## Product Change Notification

May, 2015

### 8100 Common Mode Choke Series Shipping Package Modification & Order Quantity Adjustment

Figure 1

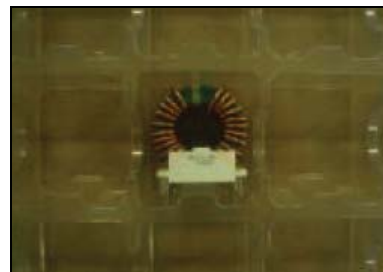
The shipping package of the Bourns® [Model 8100 Series](#) Common Mode Chokes has been redesigned to provide better component protection for normal shipping and handling environments. The original shipping package (Figure 1) offers more limited protection for the components against shock and vibration commonly encountered during shipping and handling processes than the new modified package.

The new modified package (Figure 2) is a portioned plastic tray designed to fit to the contour of each component. Each component is individually placed in a cavity which provides excellent protection against component shifting and tumbling during shipping and handling processes. This new plastic tray package has successfully passed the container drop-test.
